PLANNING

Project: TWICKENHAM STADIUM EAST STAND EXTENSION

Drawing title: LEVEL 4A PROPOSED GA PLAN

Doc ref	Project number	Drawing number	Revision
100-KSS-DR	15735	115	P03

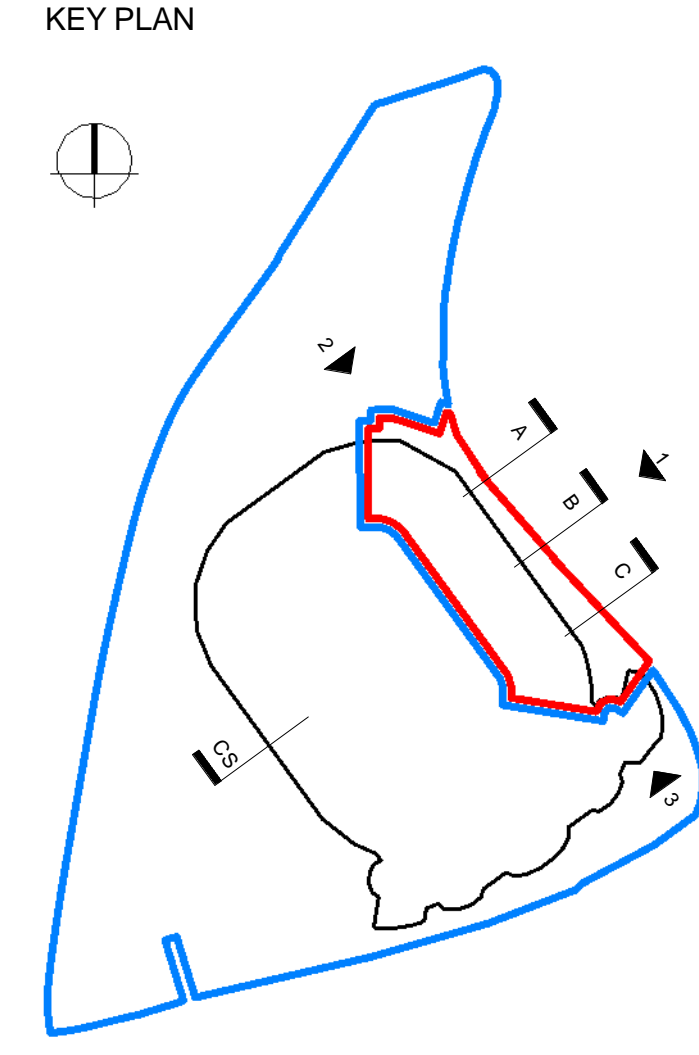
Revision Notes	
PLANNING AMENDMENTS	
A	GENERAL AMENDMENTS TO THE SOUTH END. INCREASED SHINGLES CLADDING AREA AND CURTAIN WALL REDUCED ACCORDINGLY.
A1	REDUCED MASSING AND REVISED INTERFACE WITH THE SOUTH STAND.
A2	PPC LOUVRES LOCATED TO THE BOWL SIDE HAVE BEEN OMITTED.
B	CURTAIN WALL SETTING OUT REVISED GENERALLY. SILICONE JOINTS TO TRANSOMS AND MULLION REPLACED WITH CAPPED SYSTEM. LEVEL 04 PPC LOUVRES SETTING OUT & HEIGHT REVISED. MONORAIL FOR ABSEILING REMOVED.
C	GENERAL AMENDMENTS TO THE CENTRAL ELEVATION CANOPY AT LEVEL SA REVISED GENERALLY AND STANTILEM REPLACED WITH SINGLE PLY MEMBRANE. SUPPORT COLUMNS TO ROOF CANOPY REVISED. SQUARE FASCIA TO ROOF EDGE. LEVEL SA GLAZED SCREEN EXTENDED IN HEIGHT AND PPC LOUVRES INCLUDED AT LOW LEVEL.
D	INCREASED SHINGLES CLADDING AREA AND CURTAIN WALL AREA REDUCED ACCORDINGLY. FOUR VERTICAL FINIS REMOVED.
D1	PORCELAIN PANELS WITH SLOTTED HOLES FOR VENTILATION REPLACED WITH PPC LOUVRES. EXPRESSED HORIZONTAL PATTERN TO PORCELAIN PANELS OMITTED.

D2	GENERAL AMENDMENTS TO THE NORTH END PORCELAIN CLADDING REPLACED WITH PPC ALUMINIUM CLADDING.
D3	GREEN WALL TO THE NORTH END EXTENDED AND PPC LOUVRES REMOVED.
E	INCREASED SHINGLES CLADDING AREA AND CURTAIN WALL REDUCED ACCORDINGLY.
E1	FENCELINE, GATE AND PERIMETER COLUMNS SETTING OUT REVISED.
E2	CANOPY TO TURNSTILES REVISED.
E3	PORCELAIN PATTERN CHANGED FROM HORIZONTAL TO VERTICAL.
F	PORCELAIN PANELS TO THE SOFFIT OF THE ARCH REPLACED WITH PPC ALUMINIUM PANELS. PORCELAIN PANELS SETTING OUT REVISED.
G	ROOF TO LEVEL SA (NORTH END) EXTENDED.
H	GLAZED SPANDREL PANELS REPLACED WITH METAL SPANDREL PANEL. PORCELAIN PANELS REPLACED WITH PPC ALUMINIUM CLADDING.
I	PPC LOUVRES INCLUDED FOR MECHANICAL VENTILATION.
